**Re: In the Matter of Florida Power & Light, Co. Turkey Point Nuclear Generation
Units 3-4 – Docket No. 50-250-LA and 50-251-LA**

“The NRC’s environmental assessment, in support of its finding of no significant impact related to the 2014 Turkey Point Units 3 & 4 license amendments, does not adequately address the impact of increased temperature and salinity in the CCS on saltwater intrusion arising from (1) migration out of the CCS; and (2) the withdrawal of freshwater from surrounding Aquifers to mitigate conditions within the CCS.”

RE: Calculations show increased power output is the cause of higher evaporation rates

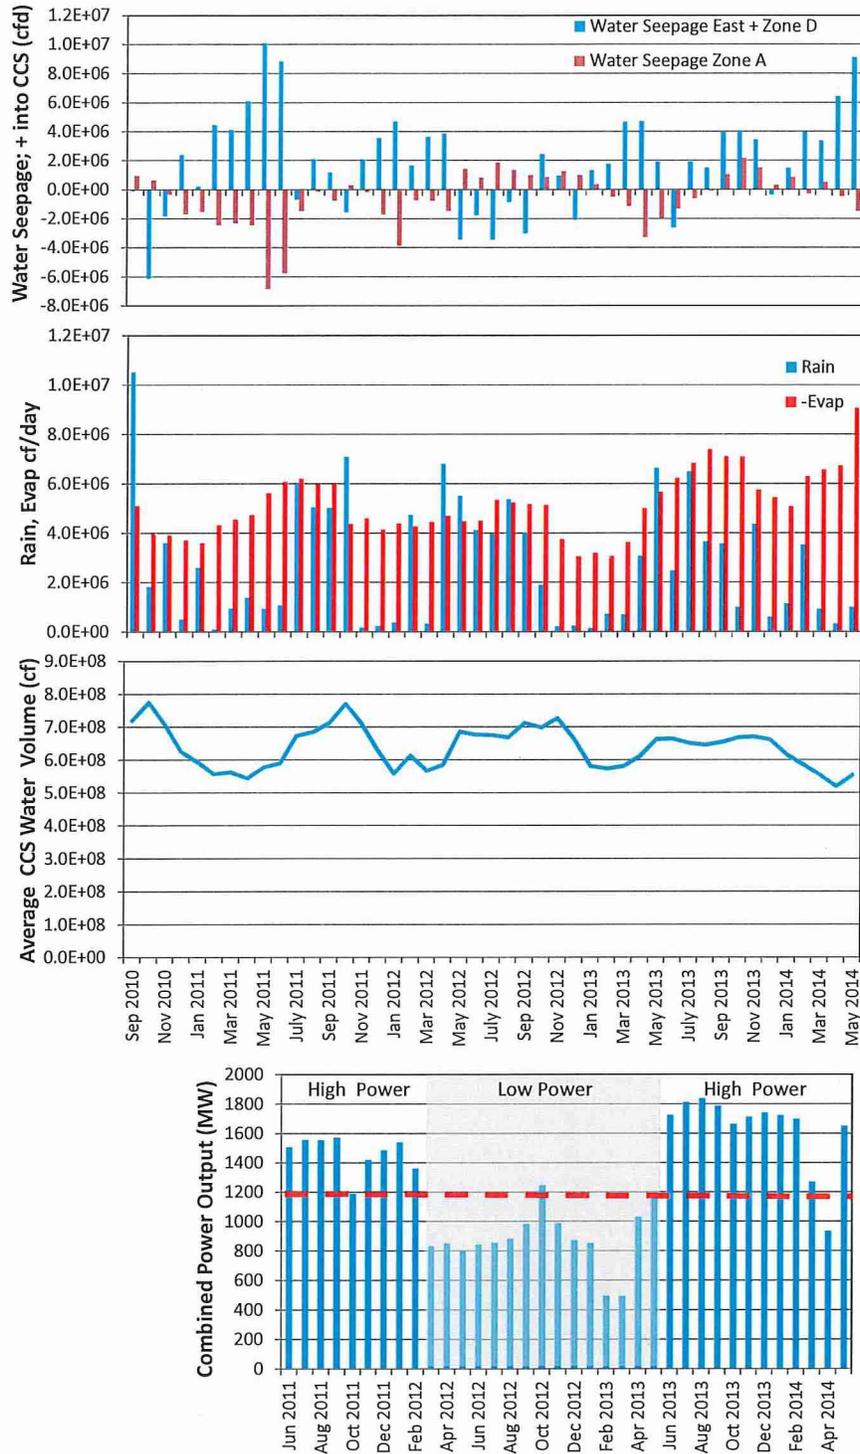
FPL has made available detailed information about the day-to-day operation of the units of the power plant that use the CCS for cooling for the period June 2011 through May 2014.¹ This makes it possible to examine how changes in power plant operations affect elements of the water and salt budget. To do this I compiled combined daily power output from units 1, 3 and 4, and I calculated the average combined power output for each month for the period that plant operations data are available, lower panel of Figures 1 and 3.

evaporation and rainfall shown in the upper panel of Figures 1 and 3. These additional sources of variation contribute to the scatter around the linear relationship between evaporation and power output.

Figure 4: Monthly evaporation is related to the average combined power output from the units that rely on the CCS for cooling. The slope is statistically significant at the level of $p = 8 \times 10^{-6}$.

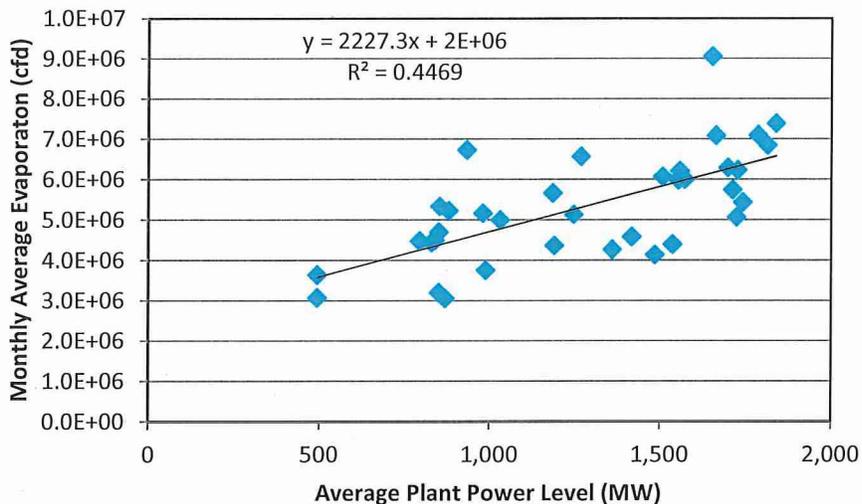
The trendline in the plot shown in Figure 4 is fitted to these data, and therefore it represents the general trend in the data rather than the underlying physical processes that might be responsible for this trend. The slope of the trendline is ~2200 cubic feet per day per MW of electric power output.

To investigate the degree to which the trend of increasing evaporation might be explained by the increased heat loading to the CCS at higher power output, I calculated the additional power dissipated from the CCS by an additional 1 million cubic feet per day increase in the evaporation rate. This calculation is based simply on the latent heat of vaporization for water, which is a physical property of water. I used the value for freshwater, ignoring for purposes of simplicity the effect of salinity on the evaporation process. The result of this calculation is 740 MW heat dissipated per 1 million cubic feet per day of additional evaporation or, in terms comparable to the slope of the plot, 1300 cubic feet per day per additional MW heat dissipated by the CCS.

The MW of electric power output and the MW of heat dissipated from a thermal power plant are related to each other by principles of thermodynamics and the operating characteristics of the power plant. The nuclear power units at Turkey Point are thermal power plants. A value of 33% is reasonable for the overall thermal efficiency of the power plants; values typically range between 30% and 40%. At a thermal efficiency of 33% the MW of heat dissipated by the CCS is exactly twice the MW of electric power produced. Applying this equivalence to the latent heat calculations results in a value of ~2600 cubic feet *per day additional evaporation per additional MW of electric power output*.

This trend is the theoretical maximum additional evaporation that could occur from the CCS, based on the assumption that all of the increase in the thermal loading is dissipated through evaporation. Comparison with the slope of the trendline from the data suggests that in actuality about 85% of the additional heat loading is dissipated by evaporation. This result is consistent with increased heat loading being the main cause for the observed increased evaporation because heat dissipation from the CCS occurs through two additional mechanisms, black-body radiation and conduction. All three mechanisms act in parallel; each accounts for a portion of the total heat dissipation. In all three increased heat dissipation occurs as the result of increased water temperature, which is the result of increased thermal loading from the power plants.

Figure 5: Monthly average rainfall is not strongly related to CCS evaporation. The value of p for this relationship is 0.269, which indicates no significant relationship.

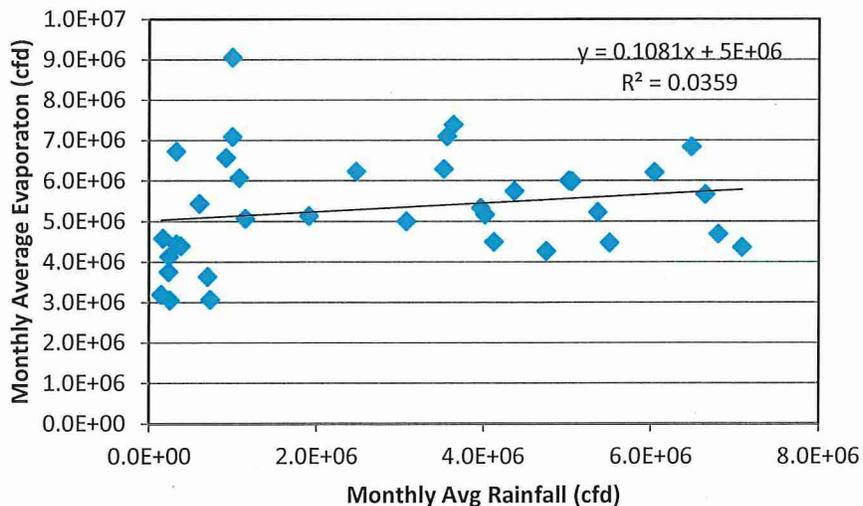
By comparison, regression analysis reveals the absence of a strong relationship between rainfall and CCS evaporation, Figure 5. Similarly, investigation of possible relationships between power output and rainfall and other elements of the water and salt budgets fails to find another relationship as strong as the one between power output and CCS evaporation, Figures 6 through 13.
